**SUBMITTAL TO THE BOARD OF SUPERVISORS  
COUNTY OF RIVERSIDE, STATE OF CALIFORNIA**

**SUBJECT:** DEPARTMENT OF WASTE RESOURCES: Contract Change Order No.1 for the Construction of Daily Cover Excavation and On-Call Site Improvements at Badlands and Lamb Canyon Sanitary Landfills, District 5 [\$921,740 –Department of Waste Resources Enterprise Funds] (Nothing Further Required under CEQA)

**CONTRACT CHANGE ORDER NO. 1**

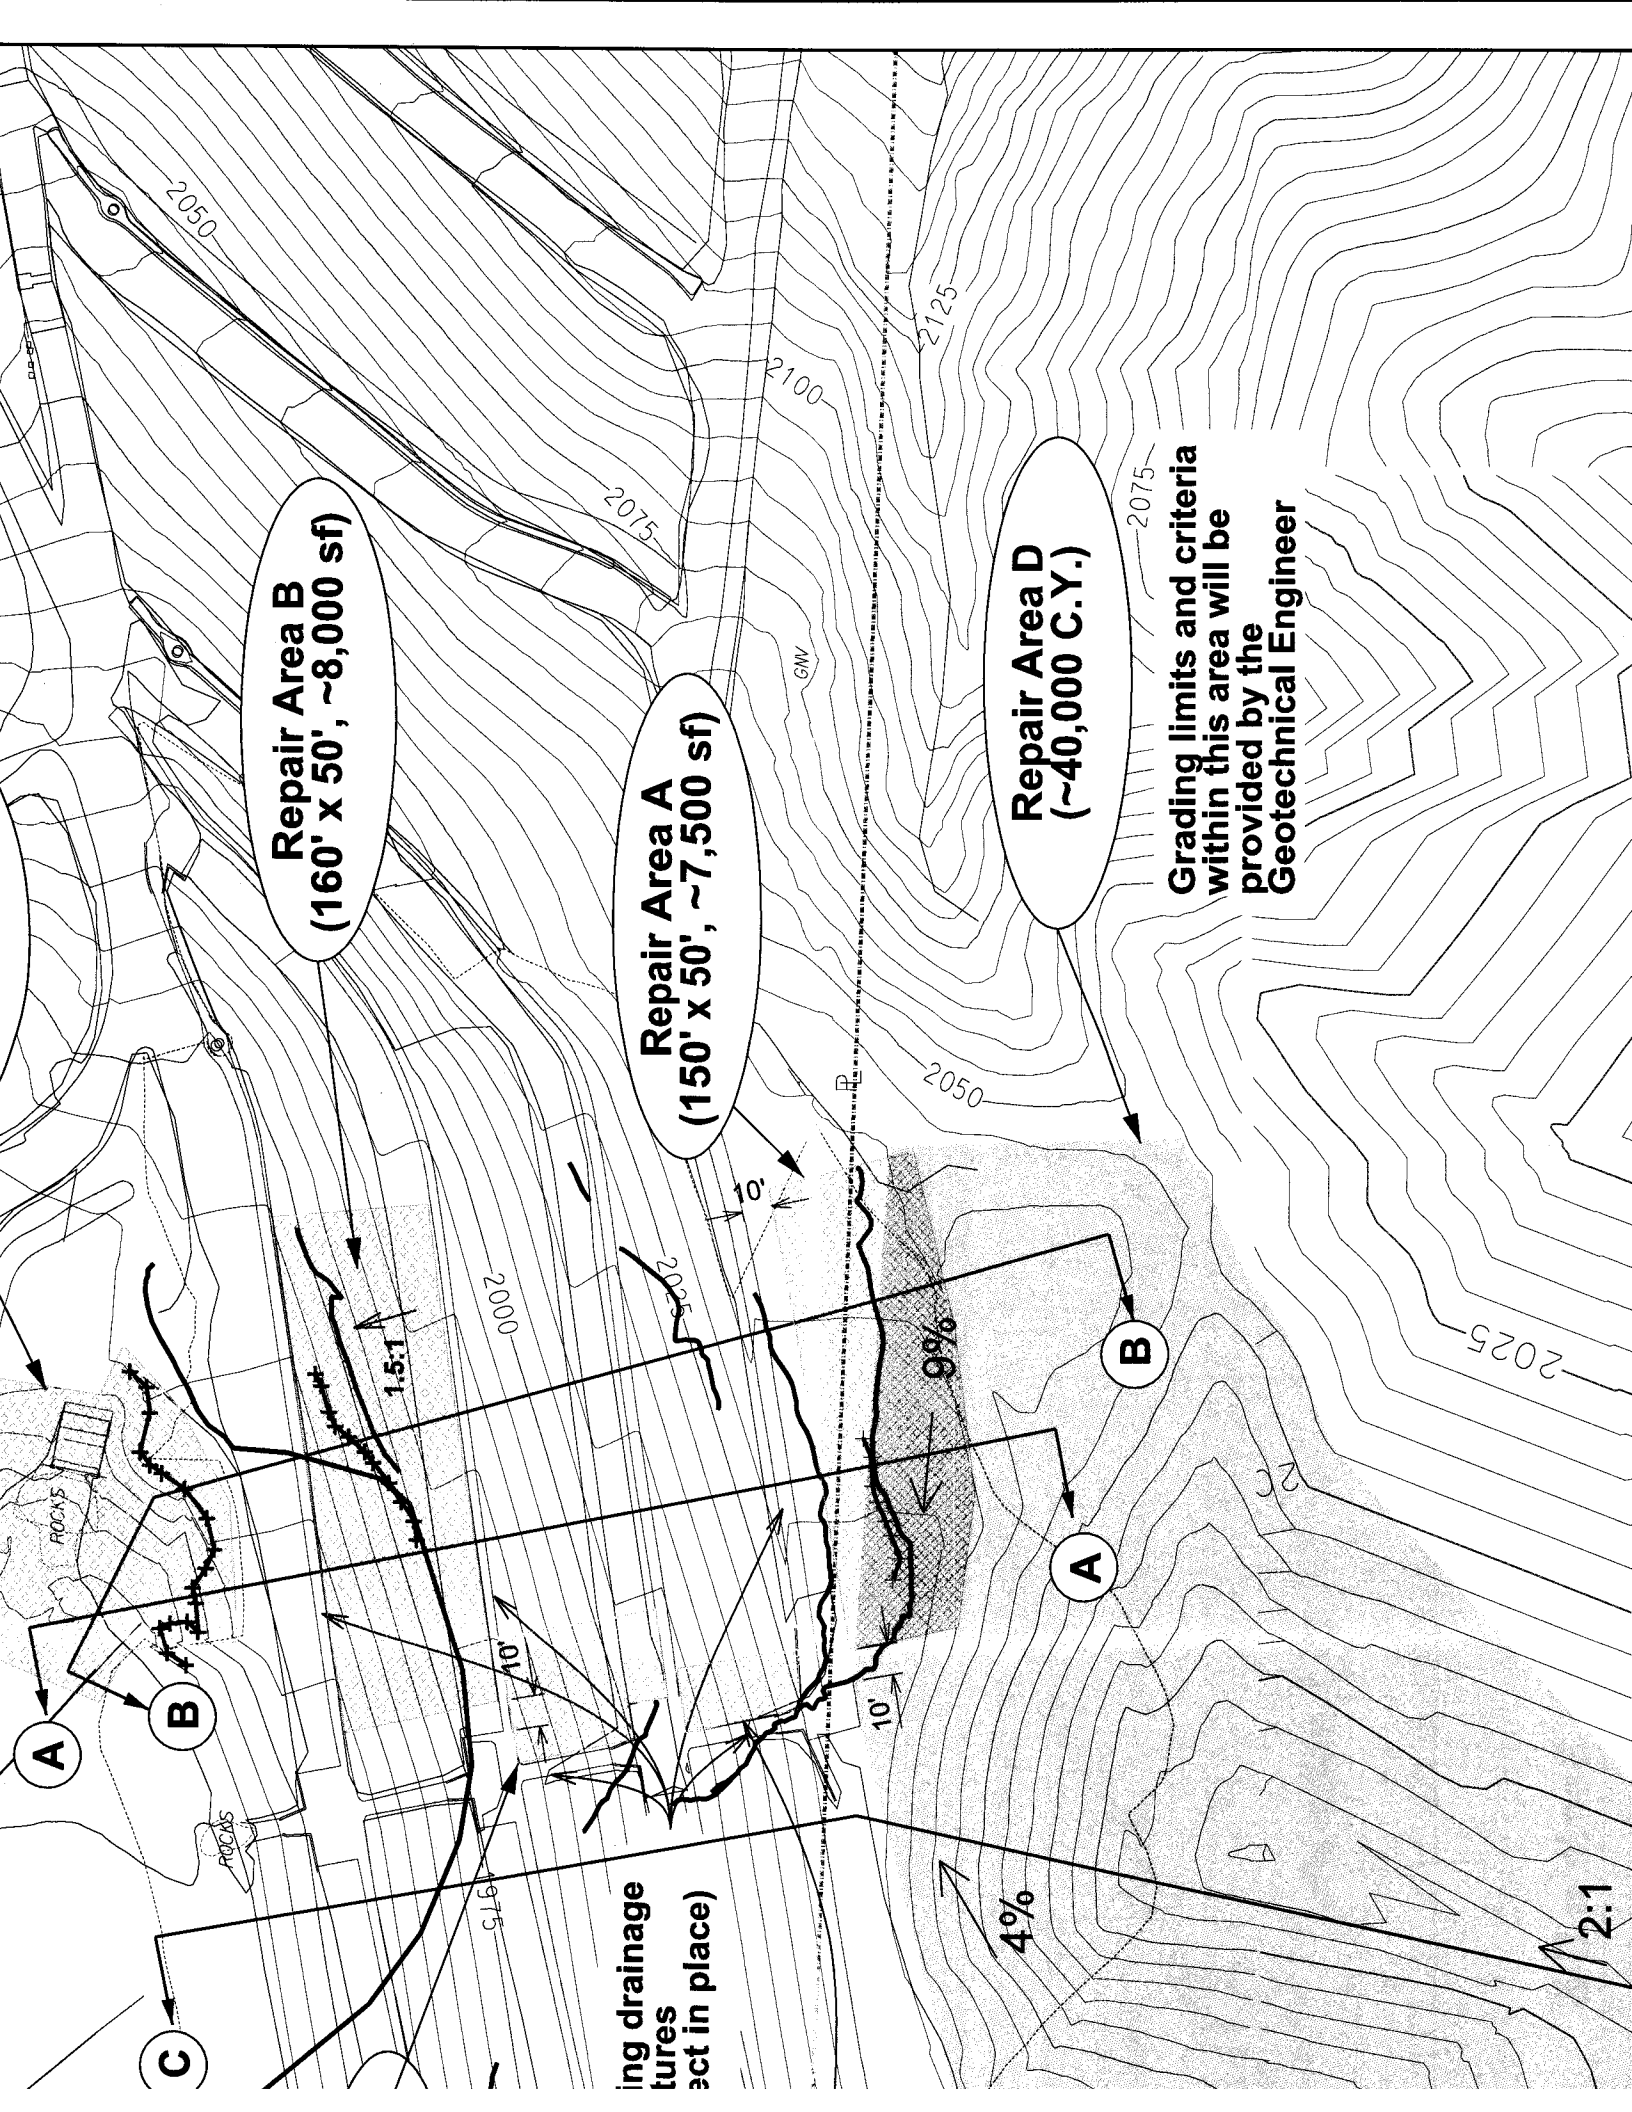
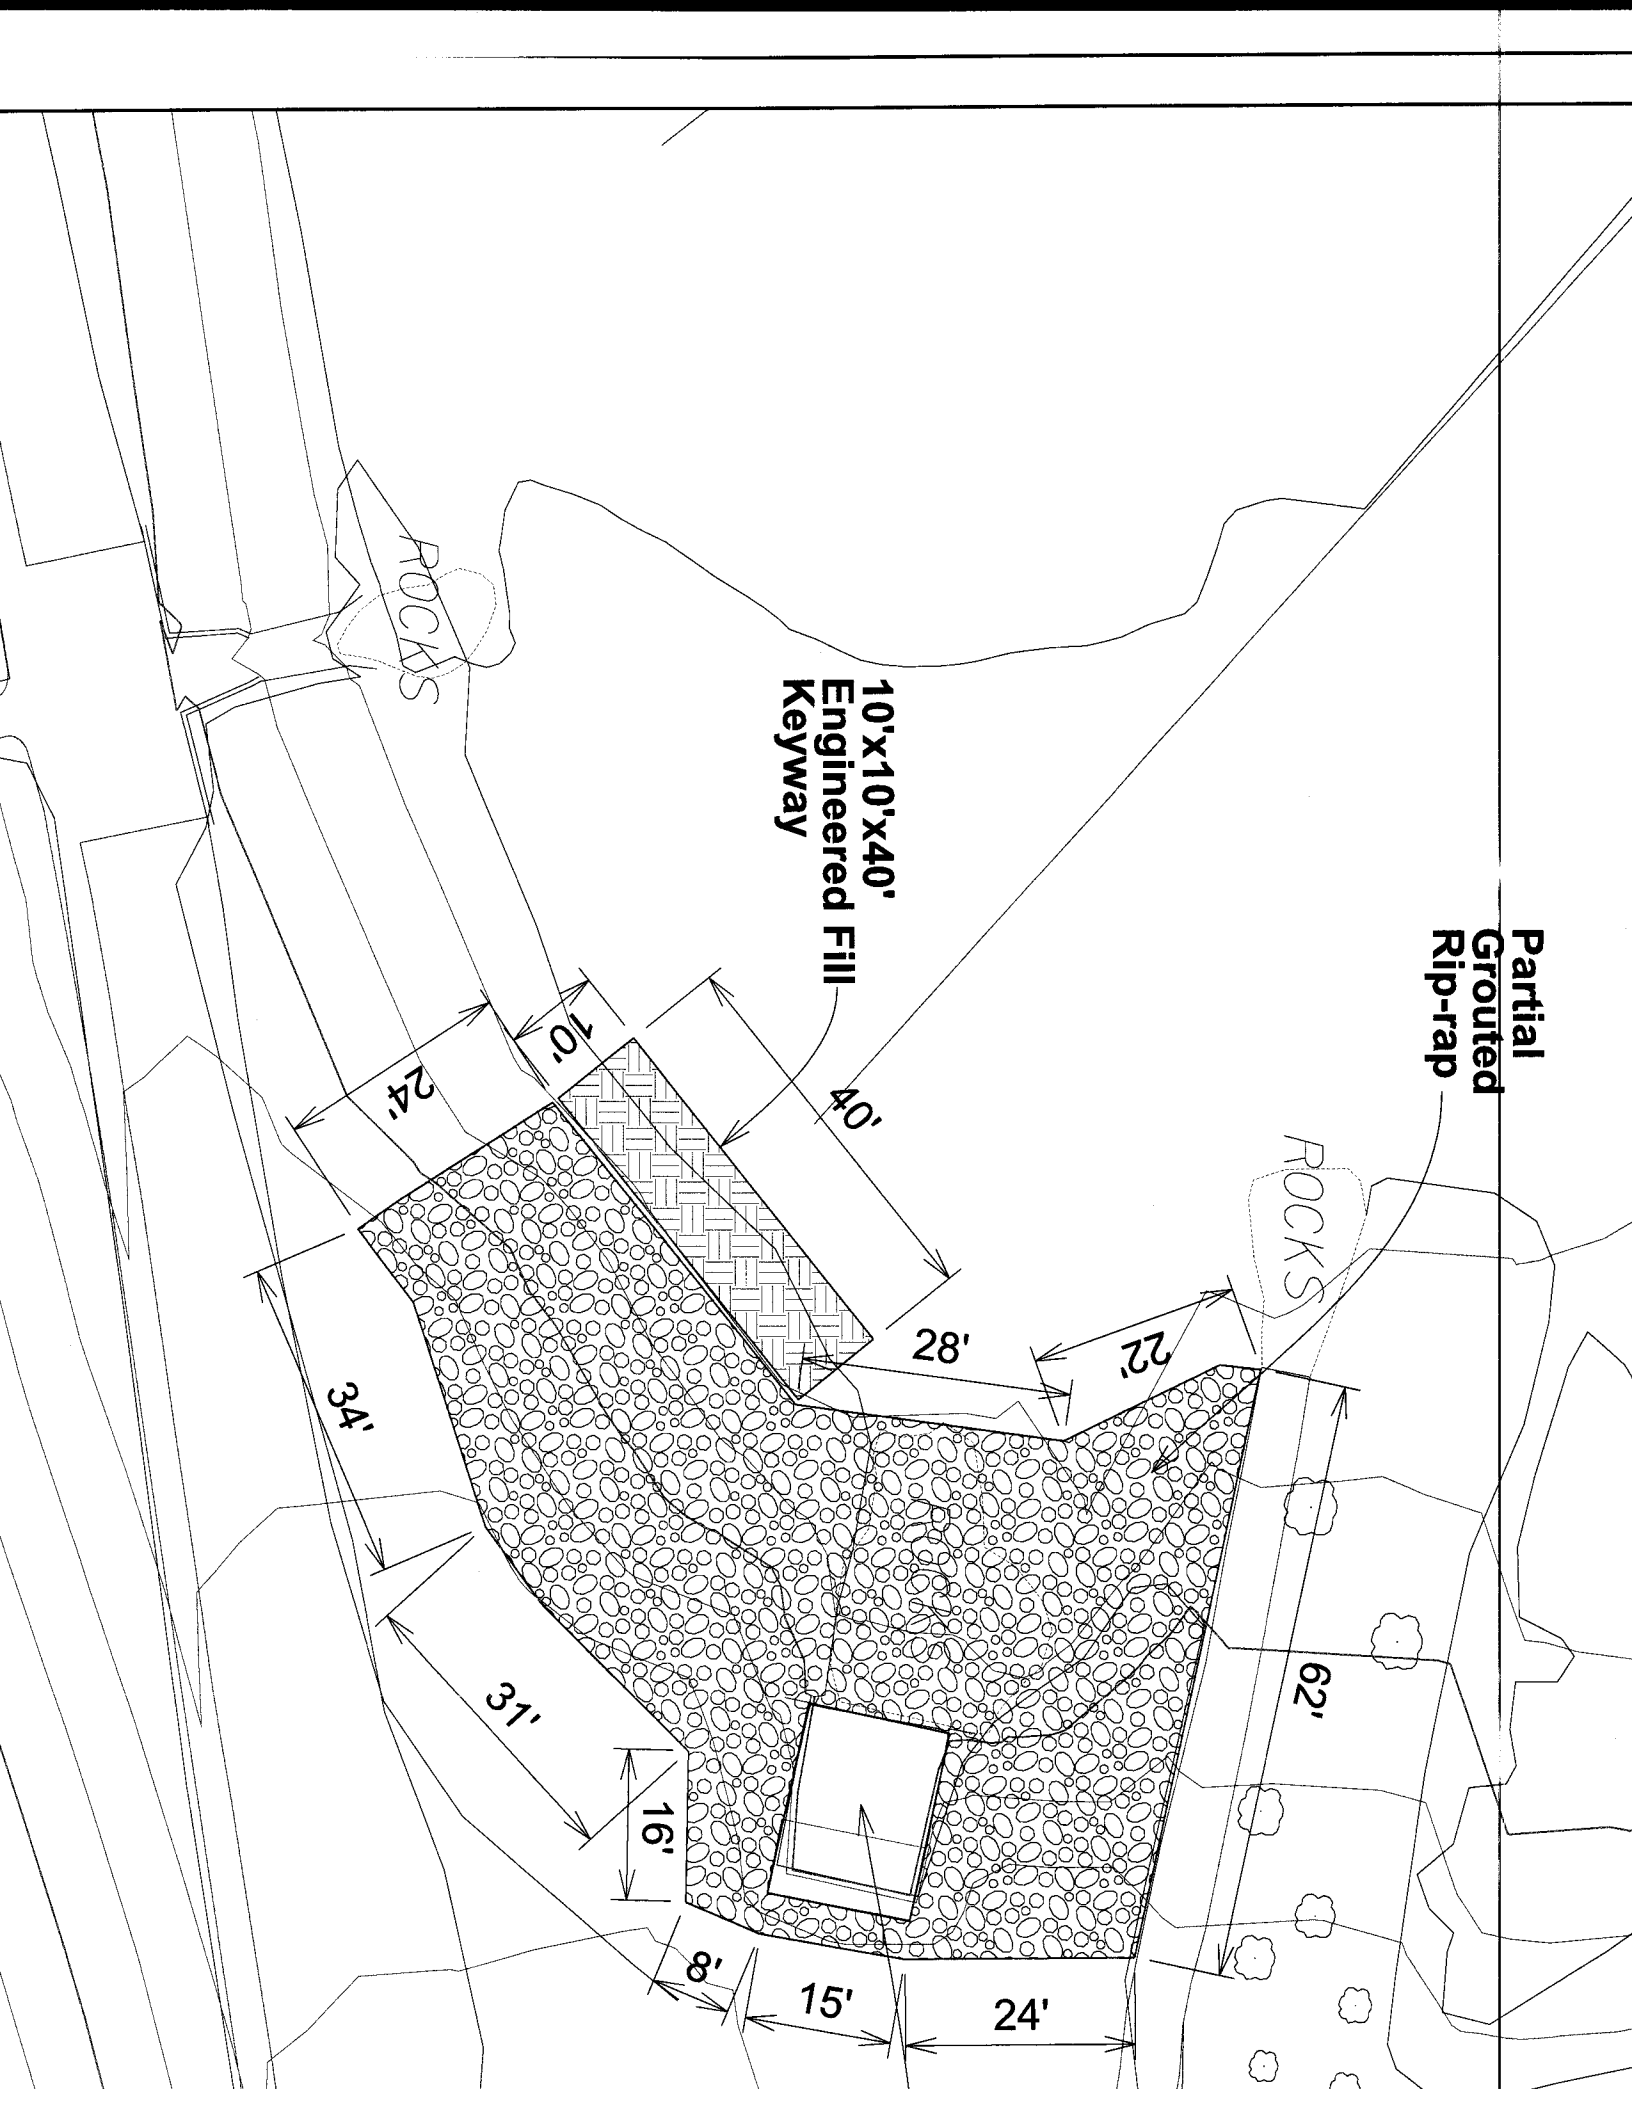
**Repair Area B**  
(160' x 50', ~8,000 sf)

**Repair Area D**  
(~40,000 C.Y.)

**Grading limits and criteria within this area will be provided by the Geotechnical Engineer**
